Product Change Notice (PCN)

PCN Number: **PCN-0451151R-01**

Product(s) Affected: PJ-037BH

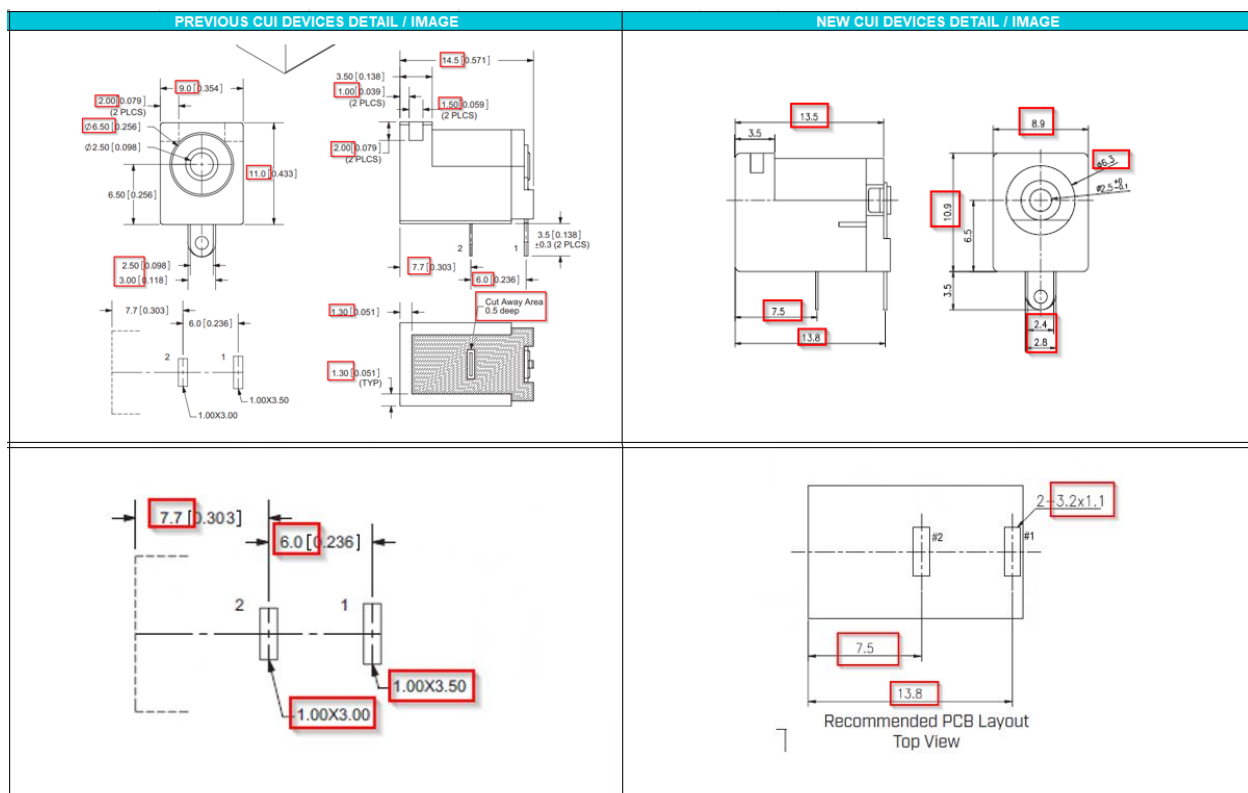
Description of Change: mechanical differences as shown below:

<table border="1"> <thead> <tr> <th></th> <th>MATERIAL</th> <th>PLATING</th> </tr> </thead> <tbody> <tr> <td>center pin</td> <td>copper</td> <td>nickel</td> </tr> <tr> <td>terminal 1</td> <td>brass</td> <td>silver</td> </tr> <tr> <td>terminal 2</td> <td>copper alloy</td> <td>silver</td> </tr> <tr> <td>plastic</td> <td>PBT</td> <td></td> </tr> </tbody> </table>		MATERIAL	PLATING	center pin	copper	nickel	terminal 1	brass	silver	terminal 2	copper alloy	silver	plastic	PBT		<table border="1"> <thead> <tr> <th>DESCRIPTION</th> <th>MATERIAL</th> <th>PLATING/COLOR</th> </tr> </thead> <tbody> <tr> <td>center pin</td> <td>copper alloy</td> <td>nickel</td> </tr> <tr> <td>terminal 1</td> <td>brass t=0.3 mm</td> <td>nickel-silver</td> </tr> <tr> <td>terminal 2</td> <td>phosphor bronze t=0.3 mm</td> <td>nickel-silver</td> </tr> <tr> <td>housing</td> <td>PBT (UL94V-0)</td> <td>black</td> </tr> <tr> <td>cover</td> <td>PBT (UL94V-0)</td> <td>black</td> </tr> </tbody> </table>	DESCRIPTION	MATERIAL	PLATING/COLOR	center pin	copper alloy	nickel	terminal 1	brass t=0.3 mm	nickel-silver	terminal 2	phosphor bronze t=0.3 mm	nickel-silver	housing	PBT (UL94V-0)	black	cover	PBT (UL94V-0)	black

MATERIAL	PLATING																																
center pin	copper	nickel																																
terminal 1	brass	silver																																
terminal 2	copper alloy	silver																																
plastic	PBT																																	
DESCRIPTION	MATERIAL	PLATING/COLOR																																
center pin	copper alloy	nickel																																
terminal 1	brass t=0.3 mm	nickel-silver																																
terminal 2	phosphor bronze t=0.3 mm	nickel-silver																																
housing	PBT (UL94V-0)	black																																
cover	PBT (UL94V-0)	black																																
 <p>MATING PLUG Jack Insertion Depth: 9.0 mm</p>	 <p>MATING PLUG Jack Insertion Depth: 9.8 mm</p>

Insertion/extraction force adjusted to 0.3 ~ 2.0 kg
